# TECHNICAL INFORMATION JDE

Type <b>Coffee Vending Machine</b>	Model <b>9100</b>	T.I. NO <b>03 - 2017</b>	
Serial Number <b>65111208</b>	Subject <b>New Fastening CLIPS for Liquid Basin Aluminium Profile</b>	ISSUED FOR (X)	Action Information <b>X</b>

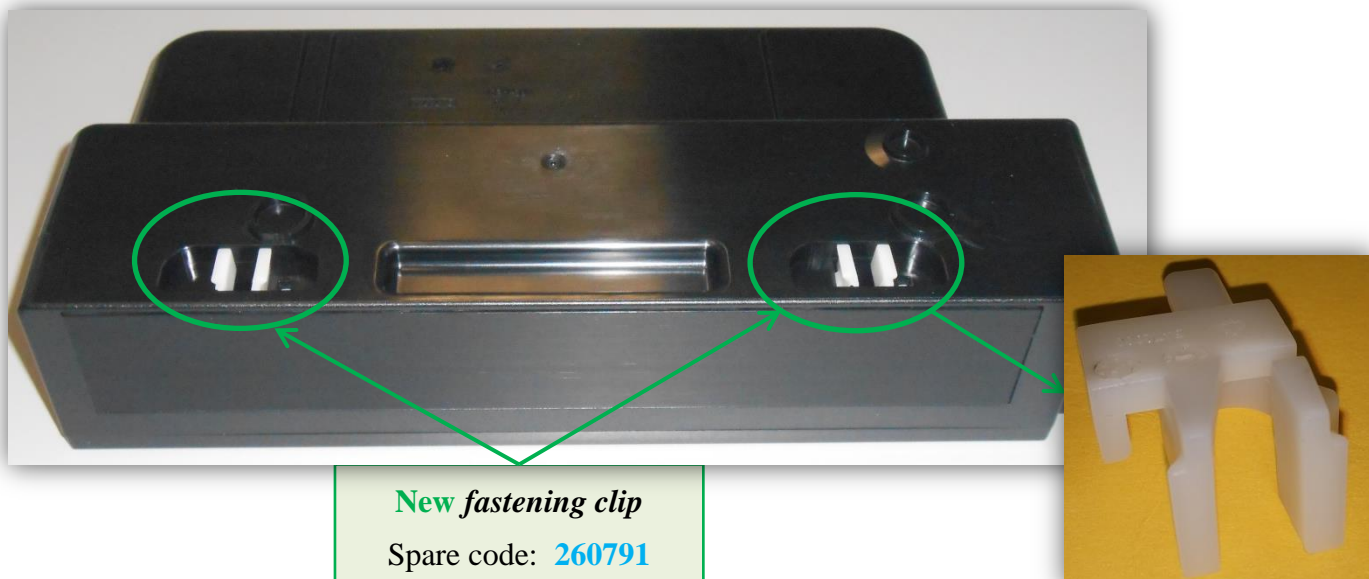
For the liquid basin cleaning it's recommended to separate the *basin aluminium profile* from the *plastic liquid basin*, when the *basin* is washed by dishwasher.

It's required a quicker removal of the *basin aluminium profile* from the *liquid basin*.

The liquid basin has been modified to create the **new fastening clips** housing.

The fastening clips allow to fix and remove quickly the *basin aluminium profile* from the *basin*.

*New liquid basin*  
Spare code: **261205**

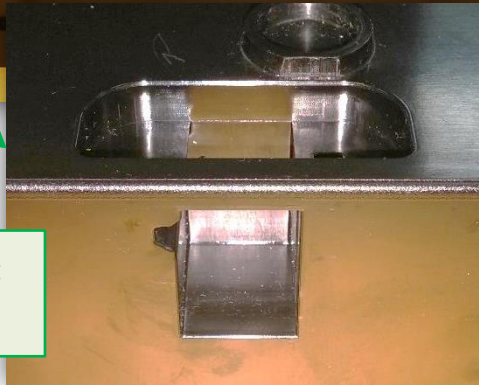
*Liquid basin detail:*  
**new clip housing**

Detail of the **pre-modification** *liquid basin*  
Spare code: **259746**

**New** *basin aluminium profile*  
Spare code: **261204**

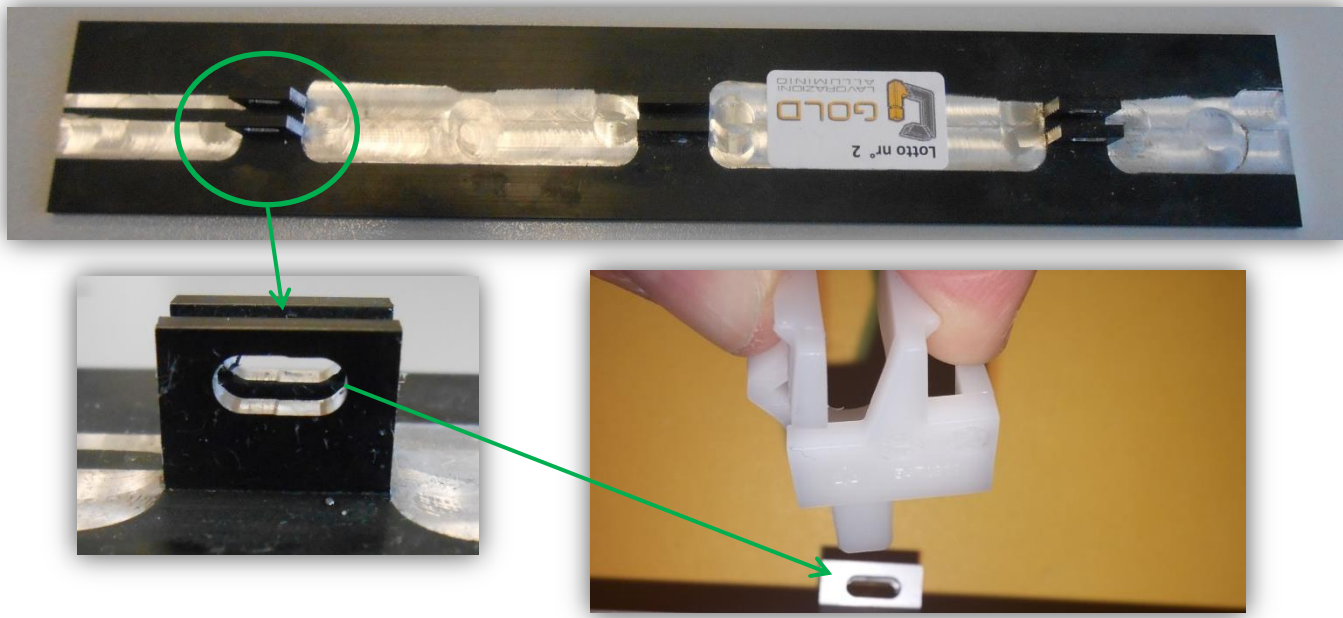
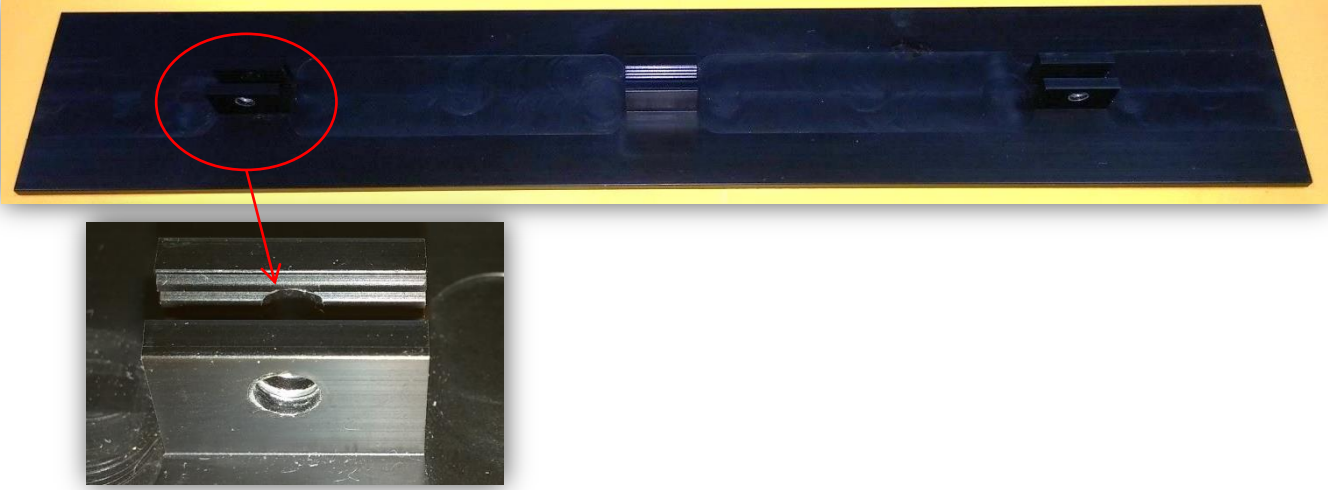
The *basin aluminium profile* has been modified to join the *fastening clips*.

**Pre-modification** *basin aluminium profile*  
Spare code: **260489**

- **New fastening clip**: **260791**

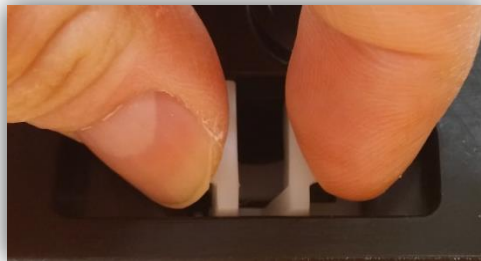
For machines previous to S/N above it's possible to use **new** liquid basin assembly.

The **new liquid basin** can be used only with the **new basin aluminium profile** and with the **new fastening clip**.
